ATTACHMENT 1

TECHNICAL SPECIFICATION BASES

ATTACHMENT 2

TECHNICAL SPECIFICATION CHANGES

Figure 6.2-1 Management Organization Chart

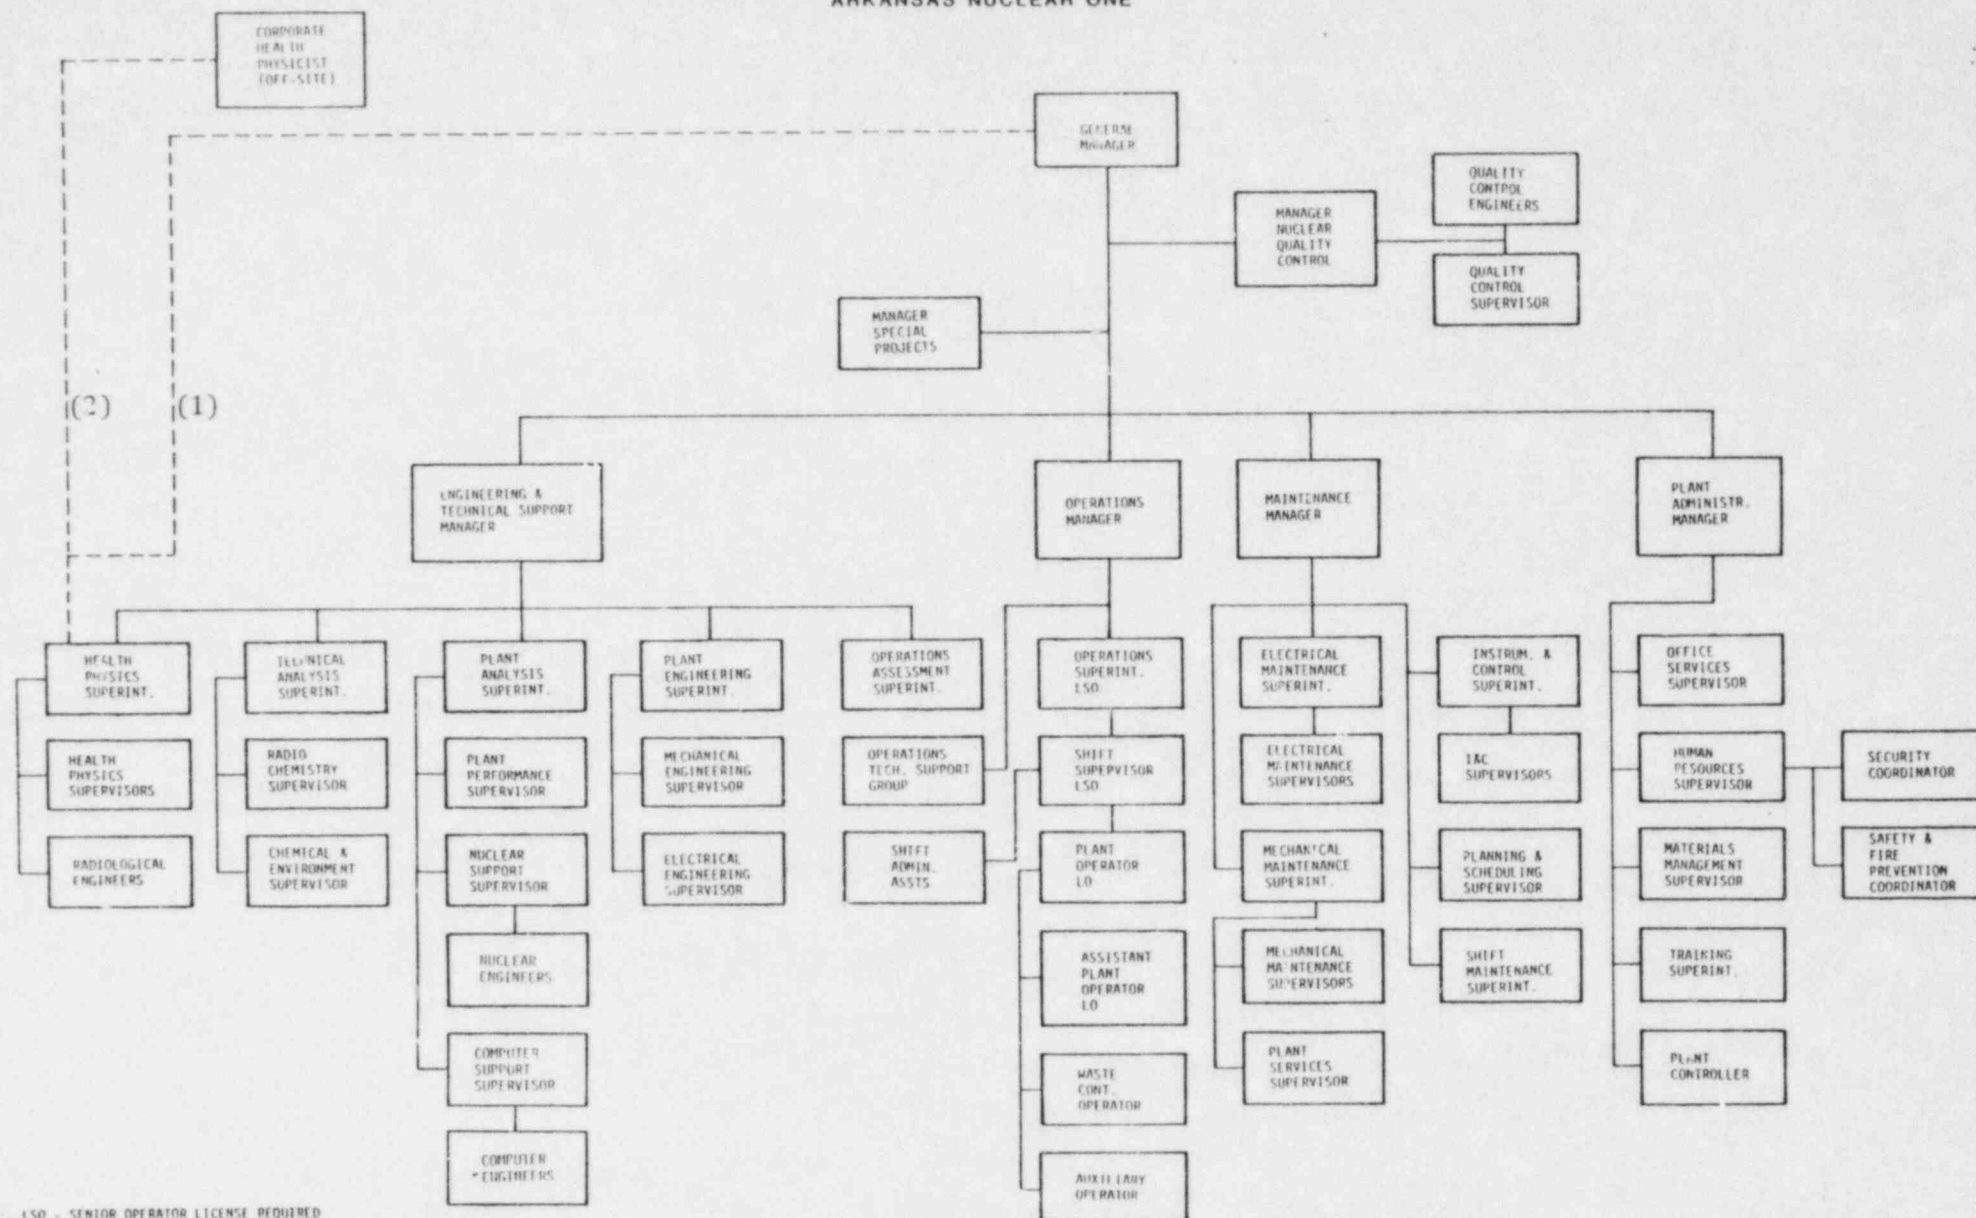
Technical Specification Figure 6.2-1
Management Organization Chart

This change is requested due to a position title change.

FIGURE 6.2-2 FUNCTIONAL ORGANIZATION FOR PLANT OPERATION

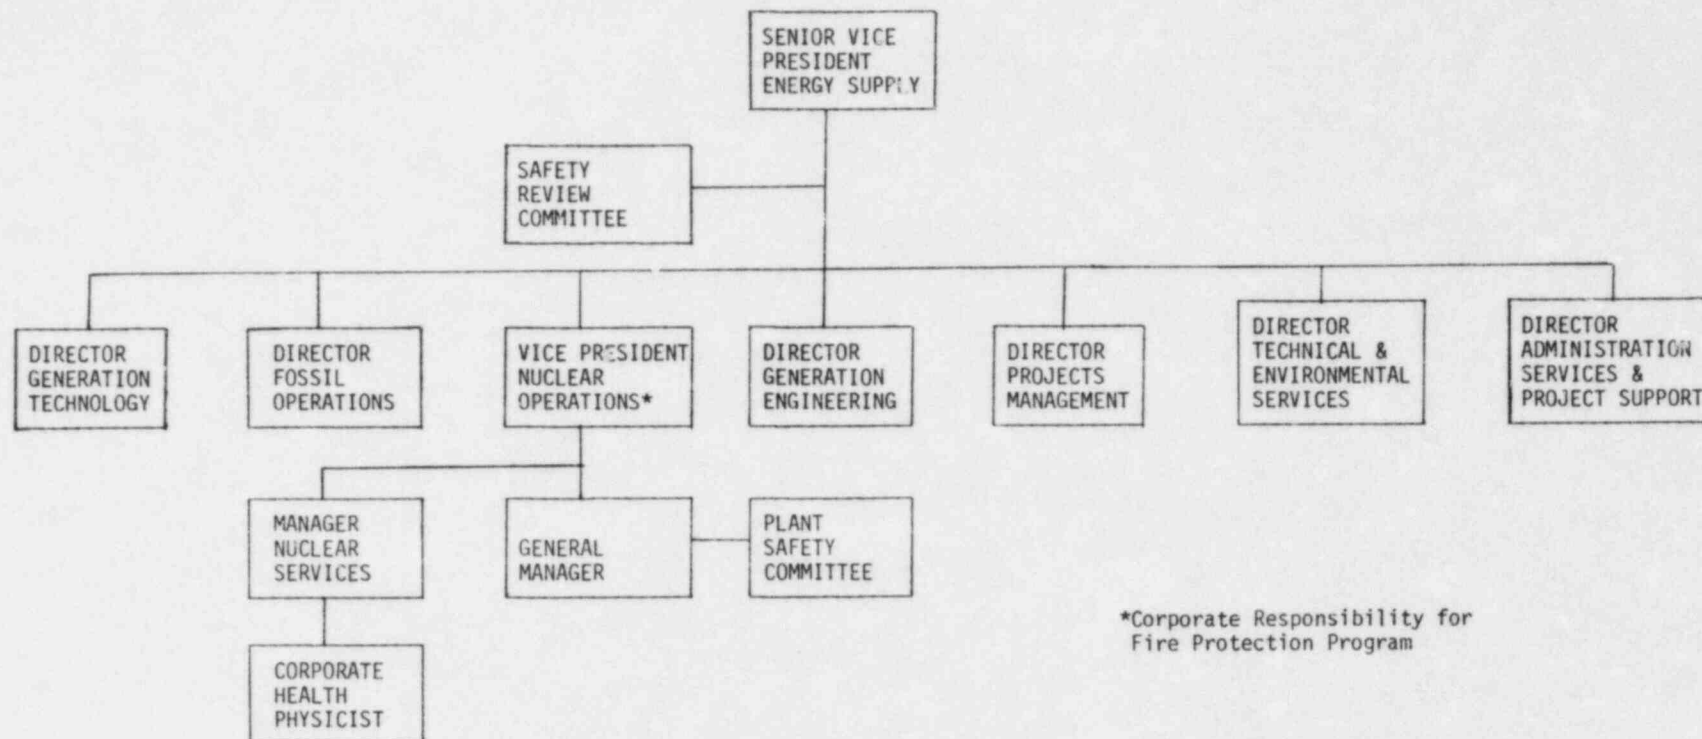
Technical Specification Figure 6.2-2
Functional Organization for Plant Operation

This change is requested due to reorganization.

FIGURE 6-2-2 FUNCTIONAL ORGANIZATION FOR PLANT OPERATIONS

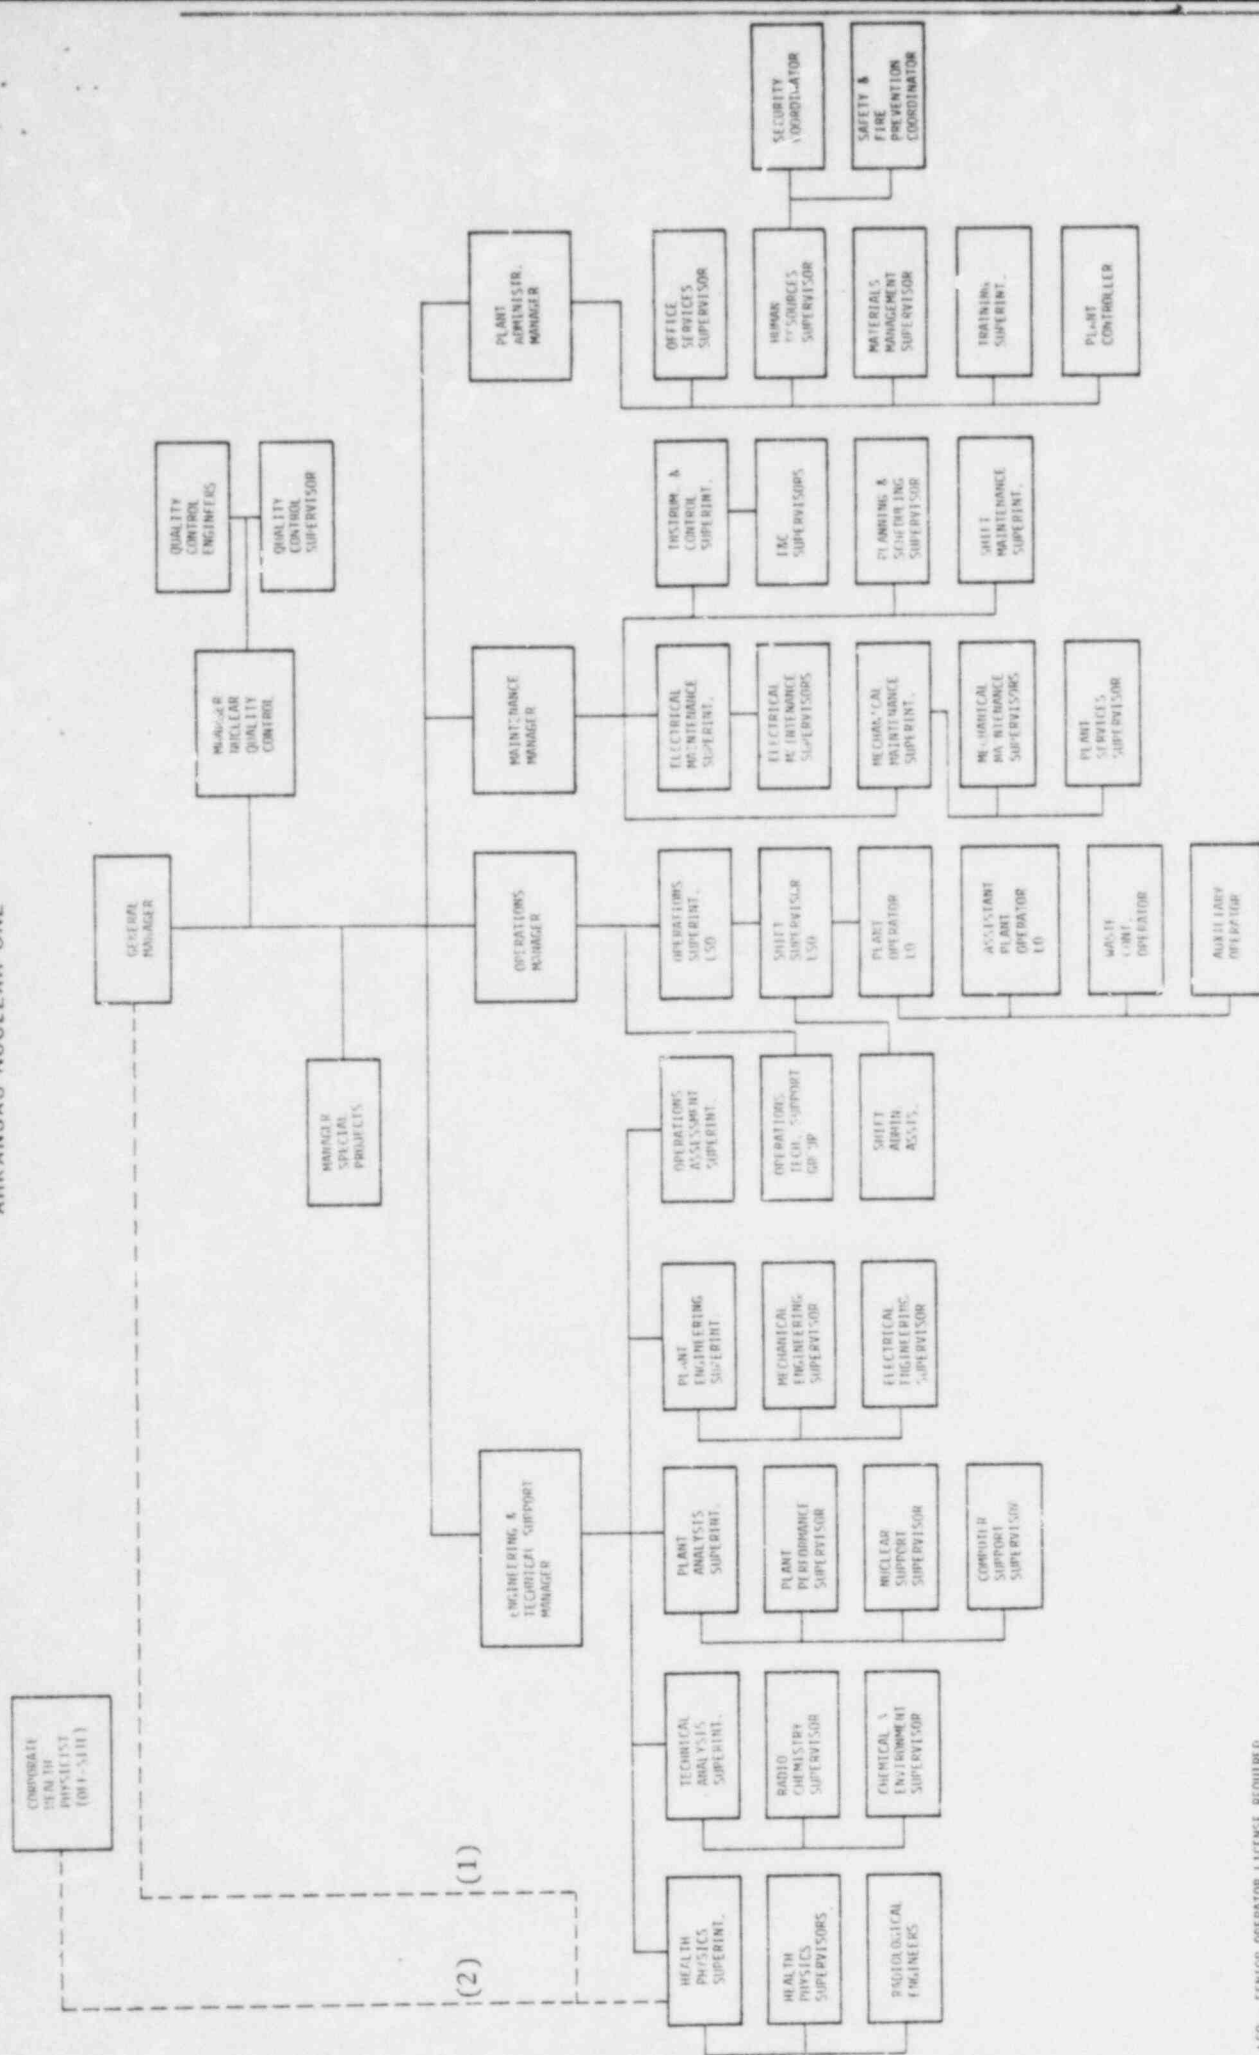
Technical Specification Figure 6.2-2
Functional Organization for Plant Operation

This change is requested due to reorganization.

Figure 6.2-1 Management Organization Chart

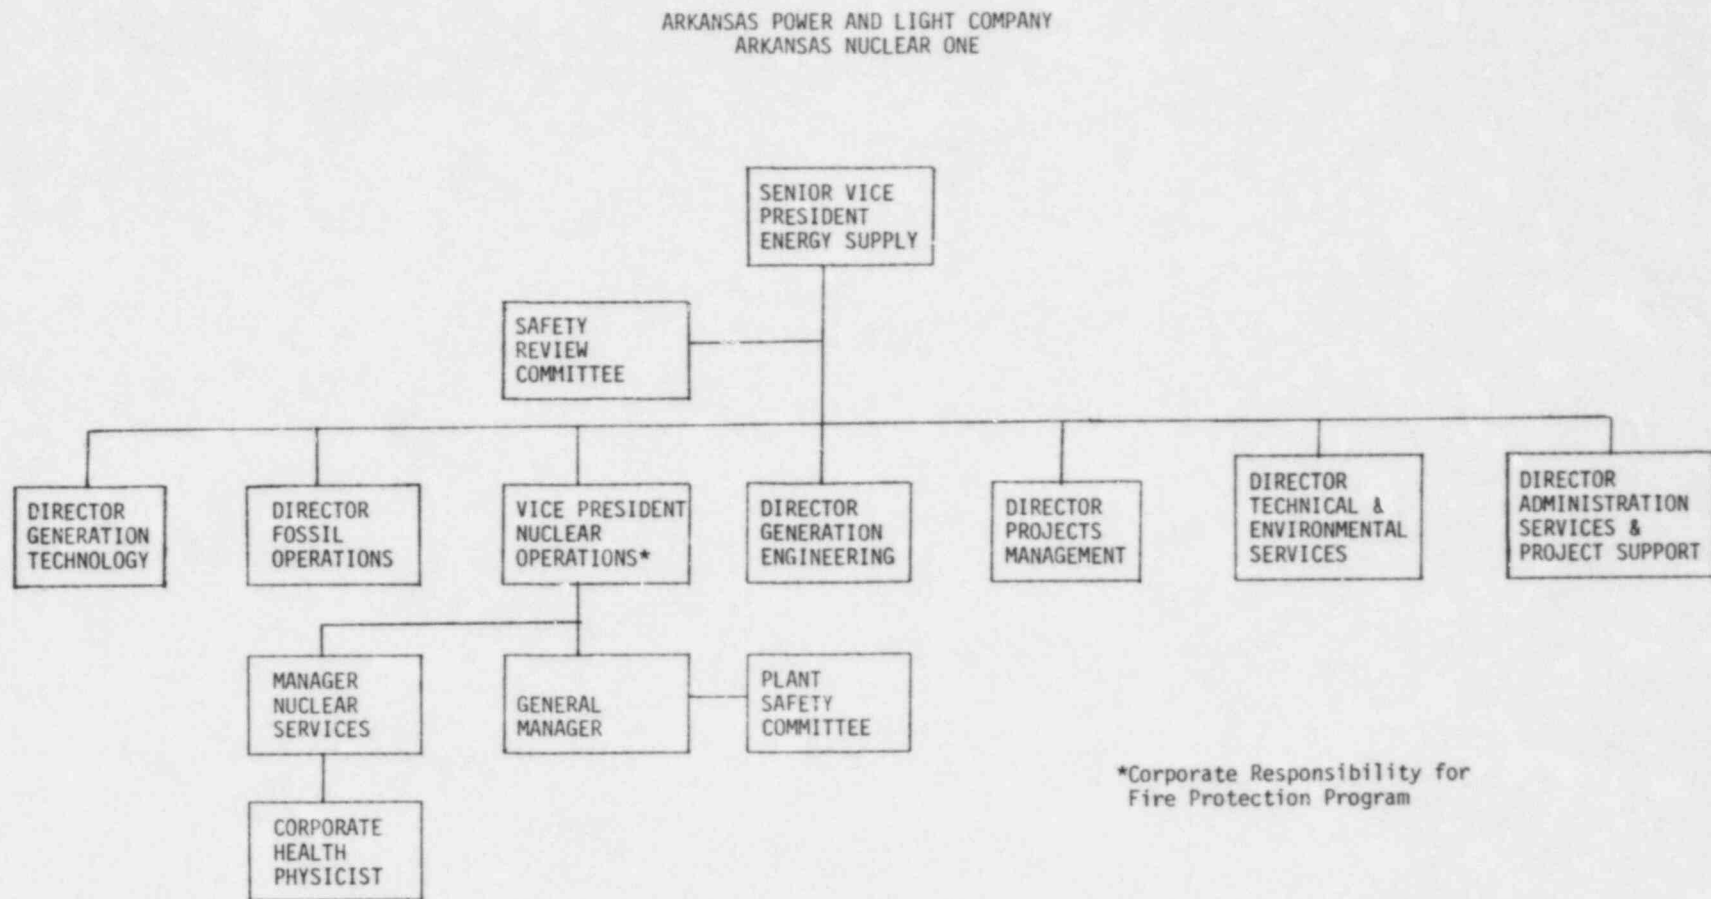
Technical Specification Figure 6.2-1
Management Organization Chart

This change is requested due to a position title change.
